# MODIFICATION PROPOSAL FORM

## MPID 246 HOUSEKEEPING – REACTIVE POWER

FORM GC1, PROPOSAL OF MODIFICATION TO GRID CODE.

Figure WFPS1.4 – Minimum **Reactive Power** Capability of **Controllable WFPS**

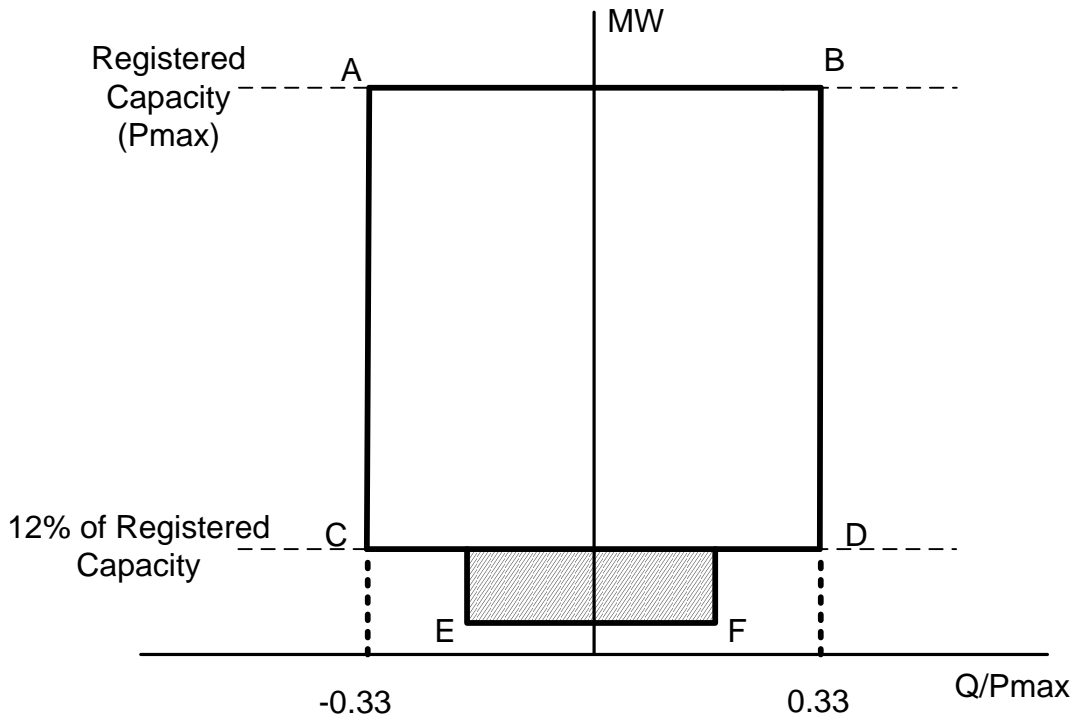
WFPS1.6.3.1 **Controllable WFPSs** operating in **Power Factor** control mode, **Voltage Control** mode or constant **Reactive Power** mode shall be at least capable of operating at any point within the P-Q capability ranges illustrated in *Figure WFPS1.4*, as measured at the **Connection Point** over the normal and disturbed **Transmission System Voltage** ranges specified in CC.8.3.2.

Referring to *Figure WFPS1.4*:

Point A represents the minimum Mvar absorption capability of the **Controllable WFPS** at 100% **Registered Capacity** and is equivalent to 0.95 power factor leading;

Point B represents the minimum Mvar production capability of the **Controllable WFPS** at 100% **Registered Capacity** and is equivalent to 0.95 power factor lagging;

Point C represents the minimum Mvar absorption capability of the **Controllable WFPS** at 12% **Registered Capacity** and is equivalent to the same **Mvar** as Point A;

Point D represents the minimum Mvar production capability of the **Controllable WFPS** at 12% **Registered Capacity** and is equivalent to the same **Mvar** as Point B;

Point E represents the minimum Mvar absorption capability of the **Controllable WFPS** at the cut-in speed of the individual **WTGs**;

Point F represents the minimum Mvar production capability of the **Controllable WFPS** at the cut-in speed of the individual **WTGs**;

The **TSO** accepts that the values of Points E and F may vary depending on the number of **WTGs** generating electricity in a low-wind scenario;

*Figure WFPS1.4* represents the minimum expected **Reactive Power** capabilities of the **Controllable WFPS**. The **Controllable WFPS** is obliged to tell the **TSO/DSO** if it can exceed these capabilities, and submit the actual P-Q capability diagram based upon the installed plant and **Collector Network** characteristics to the **TSO** during **Commissioning**.
